Proposed Turkey Point Units 6 and 7
Docket Nos. 52-040 and 52-041
FPL Response to NRC RAI No. 02.05.01-21 (eRAI 6024)
L-2013-236 Attachment 17 Enclosure A Page 1 of 7

SSHAC Level 2 Questionnaire in Support of Cuba Hazard Sensitivity Calculations

NRC RAI Letter No. PTN-RAI-LTR-041

Figure 1A The Phase 2 Earthquake Catalog and Faults of Western Cuba

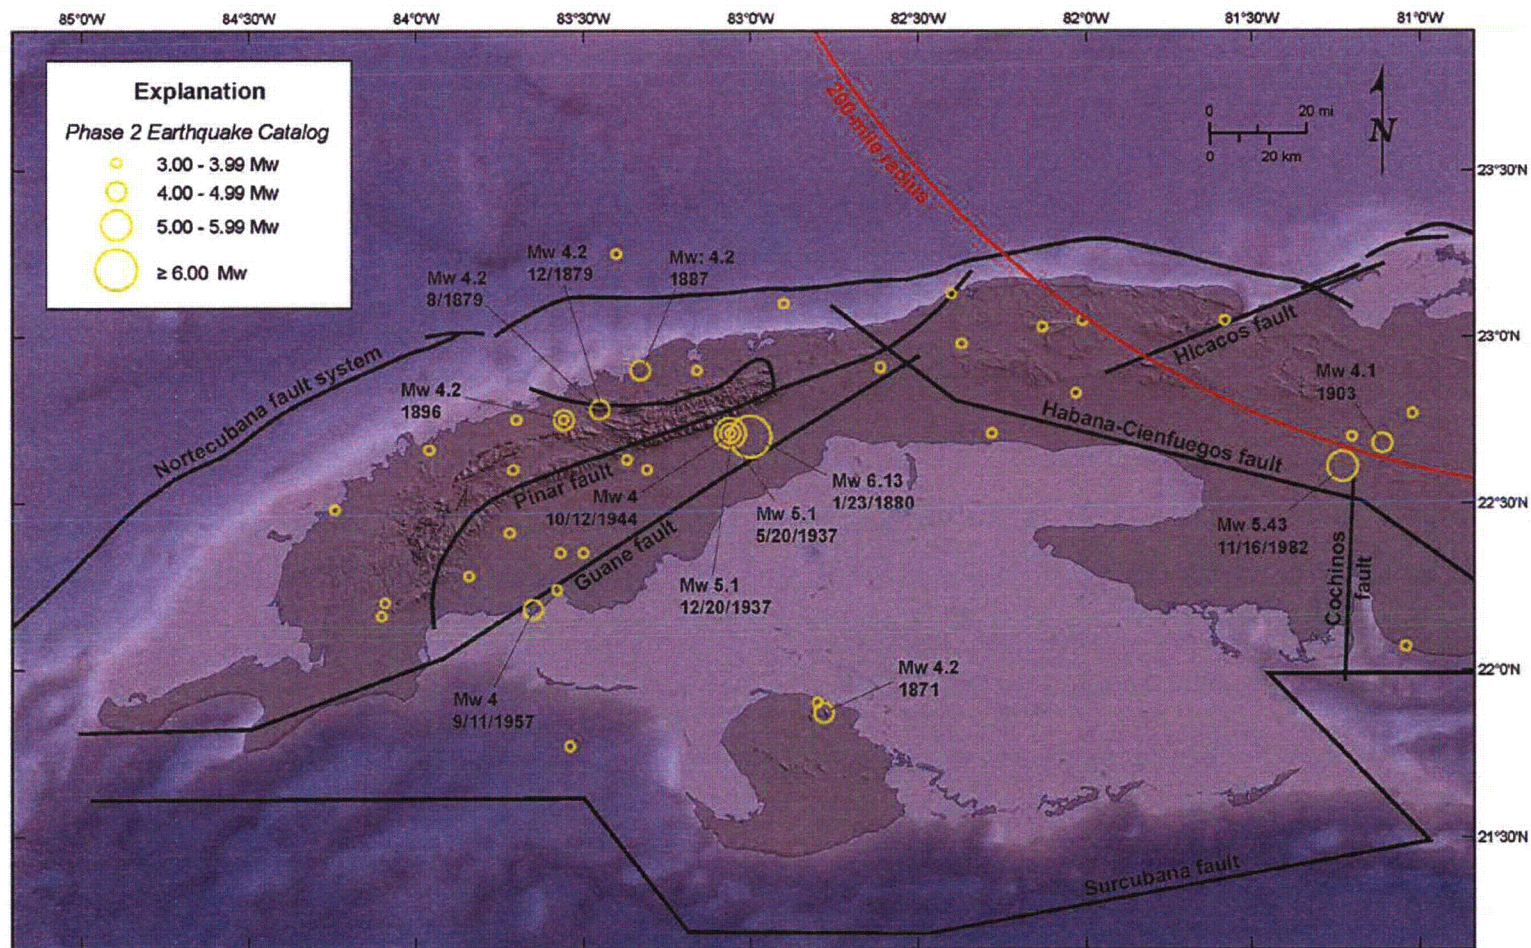
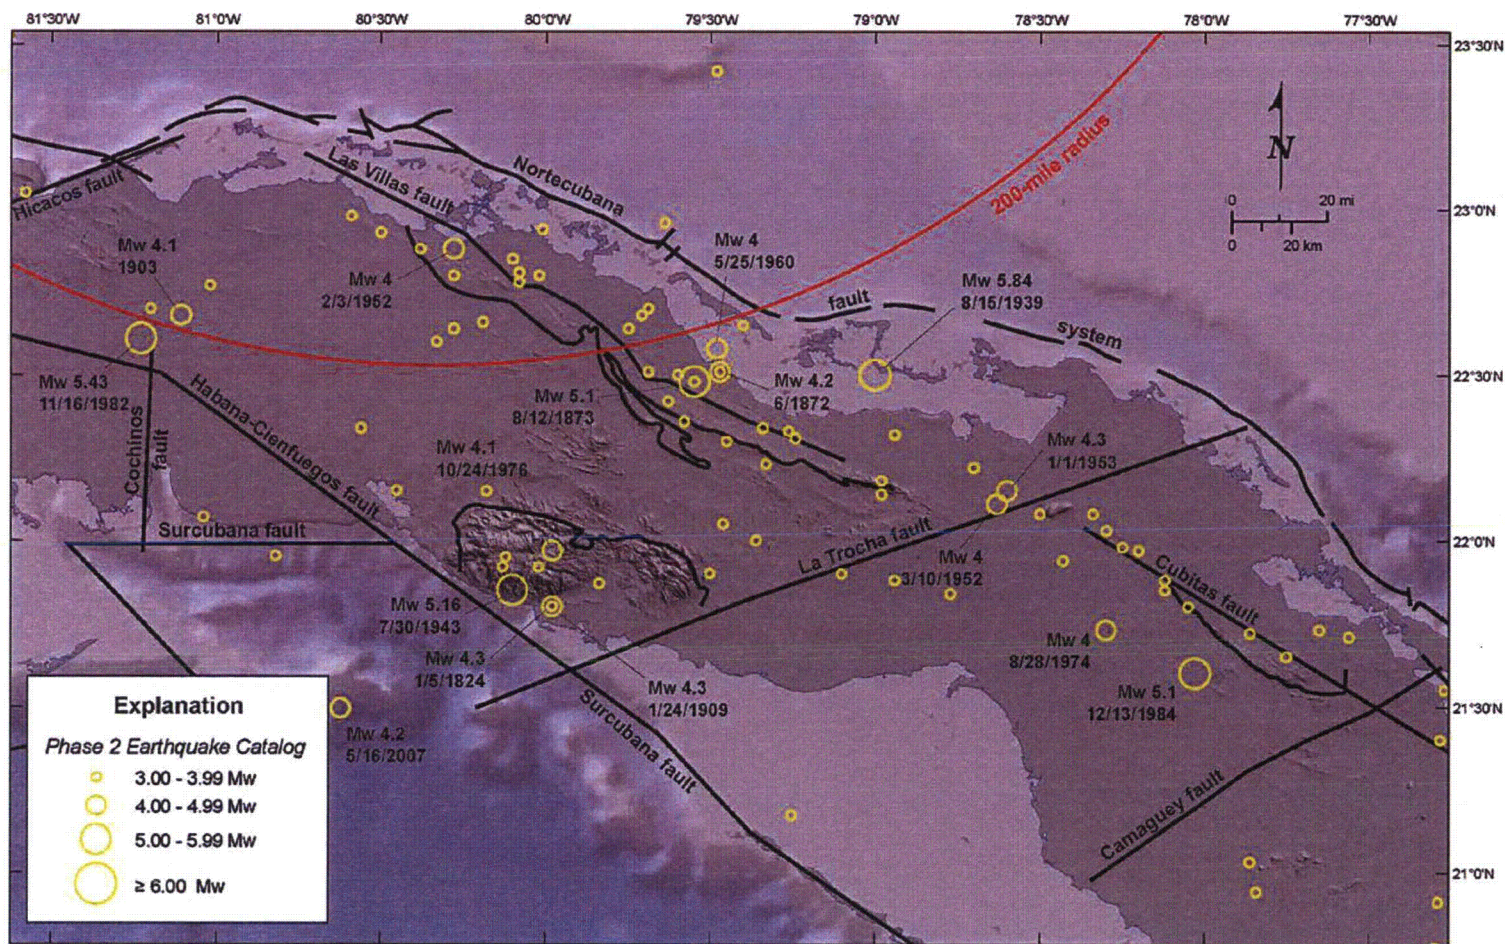
- a) Identify the Nortecubana fault or faults on seismic reflection sections and provide a map showing the surface trace or projection of the Nortecubana fault or faults with respect to topography and bathymetry.

Figures 1A, 1B, and 1C show the surface projection of the Nortecubana fault as mapped by French and Schenk (2008) (FSAR Subsection 2.5.1, Reference 492) on a shaded-relief map. Additionally, FSAR Figures 2.5.1-202 and 2.5.1-229 plot the approximate location of the Nortecubana fault on shaded-relief maps.

According to the Phase 2 earthquake catalog, a M_w 6.29 earthquake occurred on February 28, 1914, off the northeastern coast of Cuba (Figure 1C). The direct evidence required to establish a connection between an earthquake and a given fault would include at least one of the following:

Figure 2 Escarpments and Postulated Faults in the Southern Straits of Florida from Malloy and Hurley (1970)

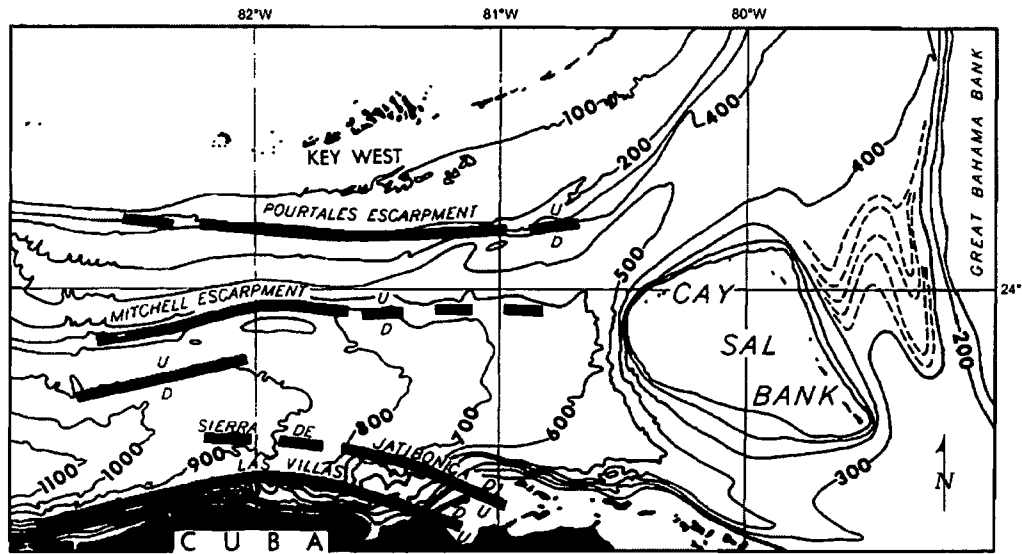
c) The FSAR states “Cotilla-Rodríguez et al. (Reference 494) indicate that the Nortecubana Fault Trench is expressed in the bathymetry north of Cuba, but this does not constitute direct evidence for activity.” Please clarify what processes give rise to a bathymetric expression of an inactive fault in a sedimentary basin.

Other studies suggest the possibility that the Nortecubana fault may be expressed in the bathymetry, but these studies do not provide detailed descriptions of the nature of this possible bathymetric expression. Malloy and Hurley's (1970) depiction of the offshore Las Villas fault extends for approximately 120 miles (200 kilometers) roughly from Matanzas Bay westward to Havana (Figure 2) and is nearly coincident with more recent depictions of the Nortecubana fault in that region (e.g., Cotilla-Rodriguez et al. (2007) [FSAR Subsection 2.5.1, Reference 494], French and Schenk 2008 [FSAR Subsection 2.5.1, Reference 492]) (Figure 1A). Due to this spatial coincidence, it is assumed that Malloy and Hurley's (1970) offshore Las Villas fault is the same structure as that portion of the Nortecubana fault as depicted in more recent literature (e.g., Cotilla-Rodriguez et al. [2007] [FSAR Subsection 2.5.1, Reference 494], French and Schenk 2008 [FSAR Subsection 2.5.1, Reference 492]). Malloy and Hurley (1970, p. 1962) provide only a very limited description of the offshore Las Villas fault and state that it "appears to be reflected in the bathymetry as a scarp" and that this bathymetric expression is "due presumably to faulting." Malloy and Hurley (1970) do not provide any description of scarp dimensions, including length, height, and continuity, and therefore, it is not clear whether their use of the term "scarp" refers to gross features in the bathymetry like the slope break north of Cuba or more localized features. Moreover, they do not explore alternate explanations that include possible submarine slumping along the continental slope and submarine erosion associated with currents and low sea level stands, as has been proposed for other bathymetric features within the Straits of Florida (e.g., Mullins and Newman 1979).

Figure 2.5.1-279 Offshore Cross Section across the Cuban Fold-and-Thrust Belt, Western Cuba

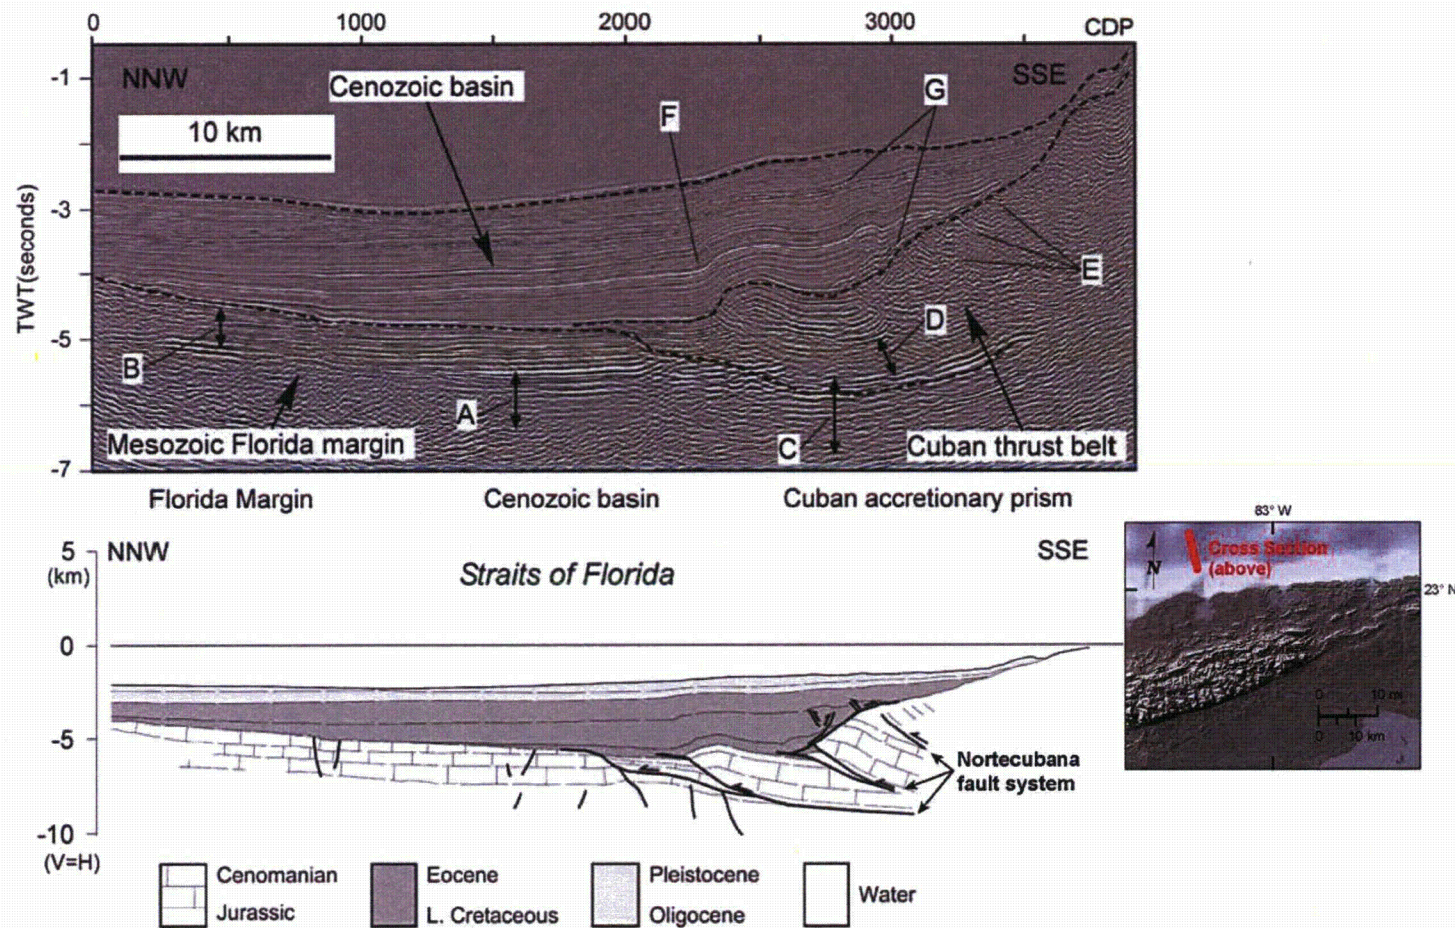
- a) Discuss the tectonic implications of the seismic reflection features above the mapped faults for Plio-Pleistocene activity in the Cuban Fold and thrust belt.
- b) Clarify how the unfaulted and uplifted Pleistocene marine terraces demonstrate a lack of capable tectonic feature.
- c) Discuss the suitability of using the schematic diagram (FSAR Figure 2.5.1-282) to conclude that faults of the Cuban Fold-and-Thrust Belt are Tertiary in age and not capable tectonic structures.

FSAR Figure 2.5.1-279 is modified slightly after Saura et al.'s (2008) (FSAR Reference 485) Figure 8, which shows: (a) an annotated seismic reflection profile from the Straits of Florida offshore north of Cuba and (b) a geologic cross section interpreted from this seismic reflection profile. According to Saura et al. (2008) (FSAR Reference 485, p. 12), the dashed lines shown in their panel (a) (and reproduced in the upper panel of FSAR Figure 2.5.1-279) represent "approximate boundaries between the main domains." In this upper panel, reflectors within the Cuban thrust belt domain appear as faulted and deformed. This deformation continues upward into the Cenozoic basin domain. Visible irregularities in the Oligocene and Pleistocene reflectors in the seismic profile are discussed by Saura et al. (2008) (FSAR Reference 485, p. 12) as "bright, irregular, internally chaotic reflections above the front of the Cuban thrust belt," which are typical of the Cenozoic section in this area (seismic unit G in Saura et al.'s [2008] [FSAR Reference 485] Figure 8a). Saura et al.

Saura et al.'s (2008) (FSAR Reference 485) panel (b) (reproduced in the lower panel of FSAR Figure 2.5.1-279) shows their interpreted geologic cross section and provides more detailed age information for the sediments. This lower panel shows that deformation and faulting associated with the Cuban thrust belt extends upward into Late Cretaceous to Eocene reflectors (dark gray) but does not appear to deform overlying Oligocene to Pleistocene reflectors (light gray). This is consistent with Saura et al.'s (2008) (FSAR Reference 485, p. 13) statement that "[the Cuban thrust belt] was a long-lived structure, which could be active at least up to late Eocene times. However, the main growth stage corresponds to the lowermost part of the sequence, which from borehole data is known to be pre-Middle Eocene." Seismic reflection lines depicted in FSAR Figures 2.5.1-280, -287, and -288 also show evidence for unfaulted late Tertiary to Quaternary sediments draping thrusts of the Nortecubana fault system, as mentioned in FSAR Subsection 2.5.1.1.1.3.2.4 (p. 2.5.1-104).

FSAR Figure 2.5.1-279 will be replaced with the revised figure shown below in a future revision of the FSAR.

Figure 1A The Phase 2 Earthquake Catalog and Faults of Western Cuba

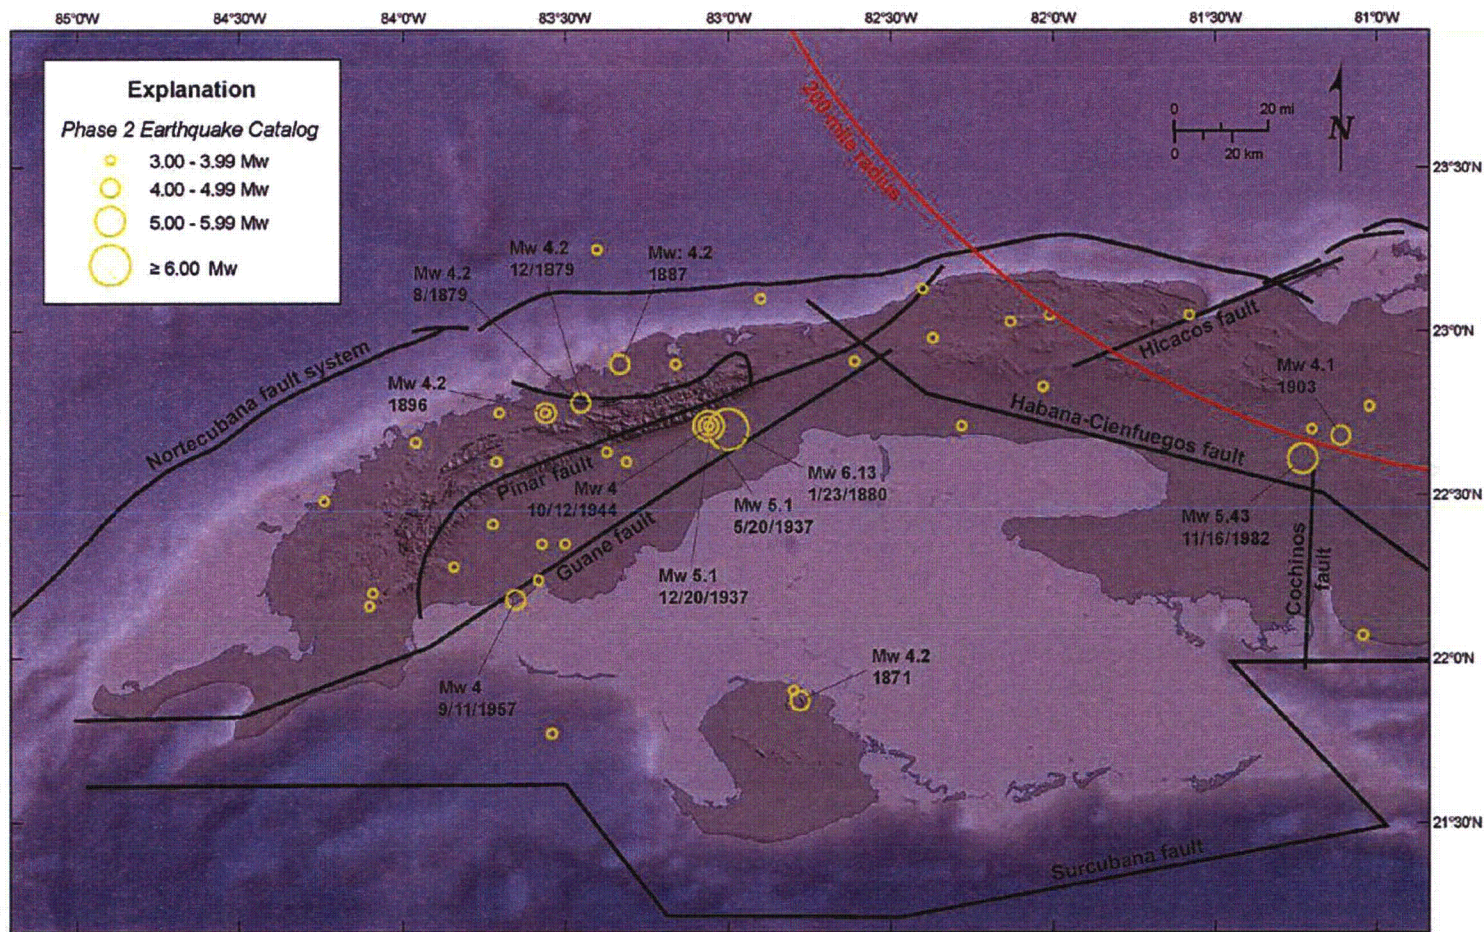
- a) Provide a map of the Hicacos fault and seismicity, including earthquake location errors, and discuss the relationship of the Hicacos fault to nearby seismicity.

Figure 1A shows epicenters from the Phase 2 earthquake catalog and faults in western Cuba, including the Hicacos fault. The Phase 2 catalog is declustered and includes earthquakes of M_w 3 and above. These earthquakes include both instrumentally located earthquakes and pre-instrumental earthquakes whose locations are based on historical felt intensity reports. The accuracy of the instrument-derived earthquake locations is limited by the lack of permanent seismic recording stations in Cuba, especially for lower-magnitude earthquakes. In fact, many of the earthquake magnitudes and locations from the instrumental era are intensity-based as well, and therefore, the uncertainties in locations of Cuban earthquakes are both high and variable. The accuracy of intensity-based locations is a function of the number and reliability of felt reports, the population density and distribution, and other factors. Even for earthquakes with well-constrained intensity centers, there remains ambiguity in the location of the epicenter because of possible seismic wave

Earthquake location errors are not shown on Figure 1A because the data with which to estimate these errors for each earthquake are not available. According to Cotilla-Rodriguez et al. (2007) (FSAR 2.5.1 Reference 494, p.518), the “epicenter determination [for earthquakes] in the western, central, and central-eastern [portions of Cuba] have limitations because of scarce or no permanent seismic stations.” The accuracy of the pre-instrumental earthquakes in Cuba is limited by the fact that felt intensity reports are restricted to onshore areas and are concentrated in near-coastal areas where population density historically is greater than the interior of the island. Both of these factors potentially bias the locations of pre-instrumental earthquakes to coastal and near-shore Cuba. Regarding the locations of pre-instrumental earthquakes in Cuba, Garcia et al. (2003) (FSAR 2.5.1 Reference 489, p. 2,569) state that, “Taking into account the complexity of the Cuban tectonic environment, the poor knowledge about the kinematic evolution of the principal fault systems, and the uncertainty in the hypocentral location of historical events (uncertainty of 15-20 kilometers or more in the historical coordinates is reasonable), it is impossible to associate earthquakes with individual faults.”

Figure 1A indicates only sparse, minor-magnitude seismicity from the Phase 2 catalog near the northeast-striking Hicacos fault, described as a normal left-lateral transcurrent fault by Cotilla-Rodriguez et al. (2007) (FSAR 2.5.1 Reference 494). The nearest epicenters from the Phase 2 earthquake catalog to the Hicacos fault are four co-located M_w 3.1 to 3.7 earthquakes that occurred near the central portion of the fault in 1812, 1852, 1854, and 1970. Another earthquake occurred in 1777 with M_w 3.7, located on strike with, but approximately 7 miles (11 kilometers) southwest of, the mapped fault trace. Likewise, Cotilla-Rodriguez et al. (2007) (FSAR 2.5.1 Reference 494) indicate sparse seismicity near the Hicacos fault, and note that no focal mechanisms are associated with earthquakes in the vicinity of this fault. According to Cotilla-Rodriguez et al. (2007) (FSAR 2.5.1 Reference 494), historical accounts suggest 10 earthquakes of less than or equal to Medvedev-Sponheuer-Karnik (MSK) intensity V (approximately MMI V) occurred in the vicinity of the Hicacos fault (FSAR 2.5.1 Reference 494). However, the association of these earthquakes with the Hicacos fault or another mapped or unmapped fault is problematic due to the uncertainties associated with the locations of both faults and earthquakes in Cuba and the paucity of available focal plane solutions.

Figure 1B The Phase 2 Earthquake Catalog and Faults of Central Cuba

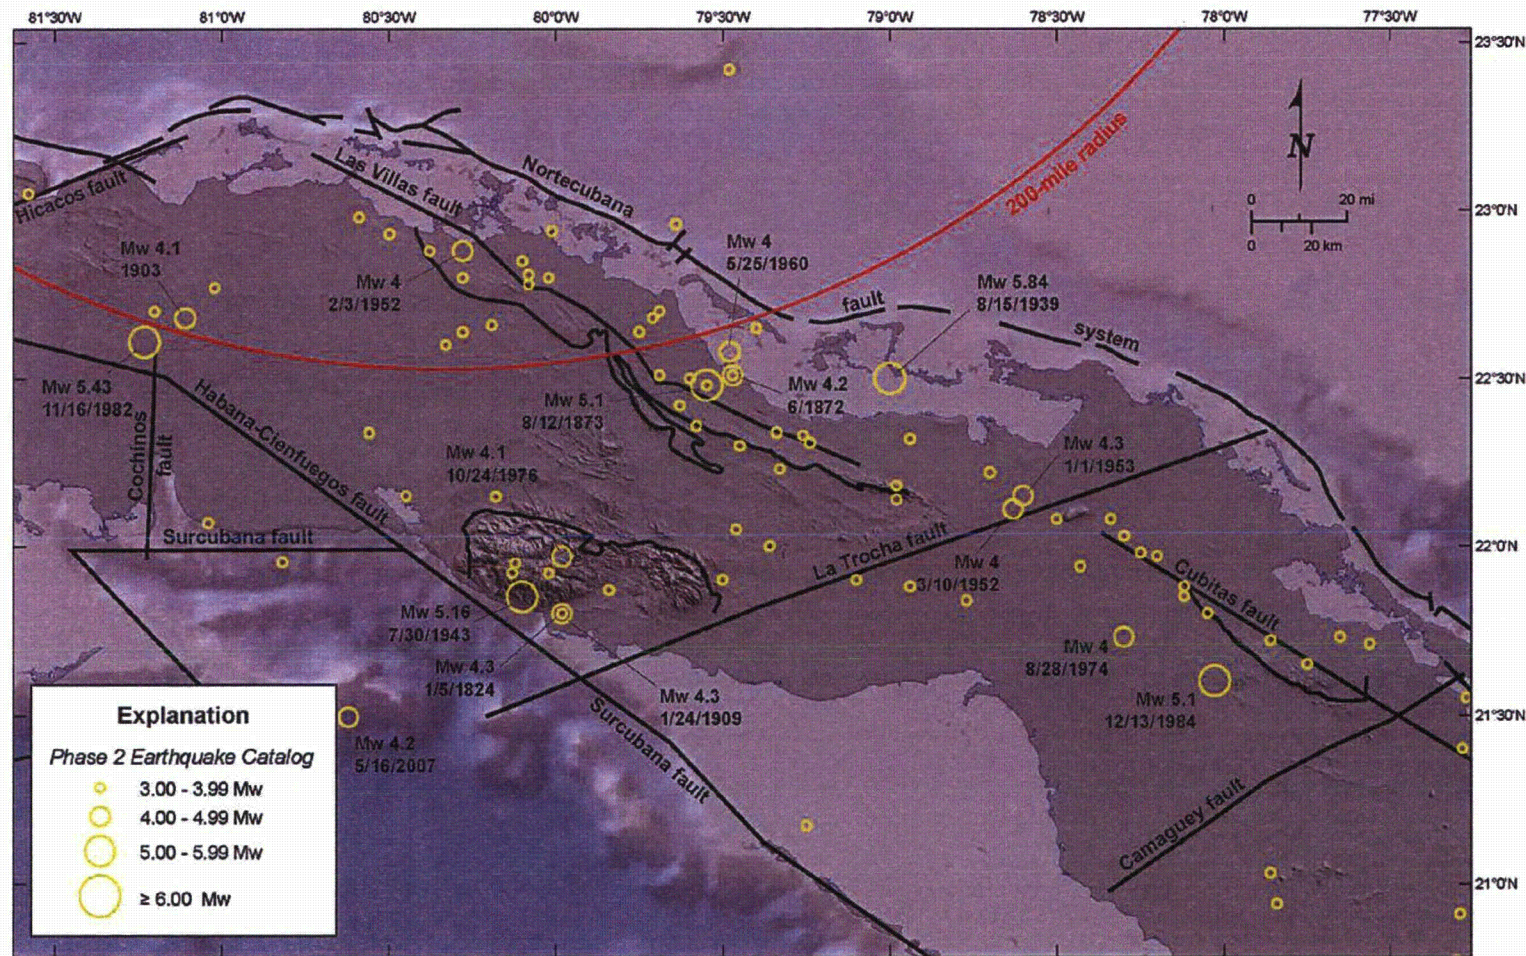
d) Provide a map of the La Trocha fault trace and nearby seismicity, including location uncertainties and discuss potential sources of the observed seismicity.

The La Trocha fault is mapped as a northeast-striking fault in central Cuba and described as a normal fault "transcurrent to the left" by Cotilla-Rodriguez et al. (2007, p. 517) (FSAR 2.5.1 Reference 494) (Figure 1B). The La Trocha fault is not shown on Pushcharovskiy et al.'s (1988) 1:250,000 scale geologic map of Cuba (FSAR 2.5.1 Reference 846). Review of Pushcharovskiy et al.'s (1988) (FSAR 2.5.1 Reference 846) maps in the vicinity where Cotilla-Rodriguez et al. (2007) (FSAR 2.5.1 Reference 494) map the La Trocha fault indicates no northeast-striking faults cutting Miocene and younger strata. Potentially, this structure is buried by the strata and could be pre-middle Miocene in age.

Figure 1B indicates only sparse seismicity from the Phase 2 earthquake catalog near the La Trocha fault. Only four earthquakes from the Phase 2 catalog are located within 6 miles (10 kilometers) of the fault trace, the largest of which is the January 1, 1953 M_w 4.3 earthquake. As described in part a) above, earthquake location errors are not shown on Figure 1B because the data with which to estimate these errors for each earthquake are not available. Cotilla-Rodriguez et al. (2007) (FSAR 2.5.1 Reference 494) suggest a possible association between three earthquakes of less than or equal to MSK intensity V (approximately MMI V) and the La Trocha fault. Some of the seismicity near this structure occurs near its projected intersection with the Cubitas fault (Figure 1B). However, as described in part a), the association of these earthquakes with the La Trocha fault or another mapped or unmapped fault is problematic due to the uncertainties associated with the locations of both faults and earthquakes in Cuba.
